Minutes – East Kildonan-Transcona Community Committee – June 13, 2017

Item No. 13 Land Dedication Reserve Fund – Transcona Pool Toddler Fencing (Transcona Ward)

Title: Land Dedication Reserve Fund – City of Winnipeg Community Services Department – Transcona Pool Toddler Fencing

LOW FENCE FOR DECK AREA

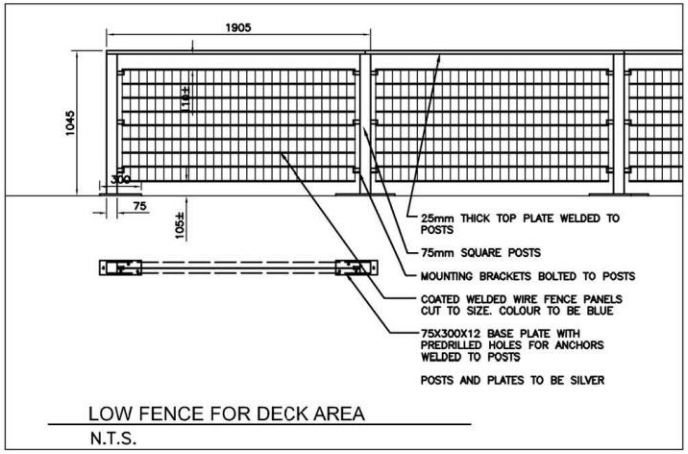
From on discussion on site on Friday we have prepared a sketch detail and overlay plan of the proposed barrier between the spray park and the pool.

The barrier would be made of individual panels set on the curve shown to provide a physical barrier between the two play areas.

Jennifer and Greg - will this barrier be acceptable on the pool deck? The barrier is set so that there is a minimum of 1.5m from edge of spray pad to fence line and 1.5m to the pool apron.

Ben and Earl - please obtain pricing from your subcontractor for the fence panels (18) in three different metal options - galvanized steel

powder coated sparkle silver; aluminum with a clear coat; and stainless steel. This is for the frame only. The inner panel is to match the wire fence in blue.

Russ - please confirm that the overall design and layout are acceptable.

At the site meeting on Tuesday Jennifer and Dean reviewed the concerns with user flow and guard access with the extent of the barrier railing. We have prepared a revised plan showing the modified extent of the railing to not conflict with the ladder exit and guard chair at the pool. This will allow free flow out from the ladder without channelizing people between the pool and railing. The other concern was the pinch point that would be created between the railing in the pool at the beach entry and the proposed railing at the spray pad. This would force people to choose which way to go and may cause conflicts with two way traffic.

The lowest price is for galvanized metal, which is susceptible to rust but provides the lowest cost, the second is for aluminum which the City uses on street for barriers and transit furniture, and the third is for stainless steel, which is used in the pool for ladders and railings. We would recommend the aluminum based on durability and cost.
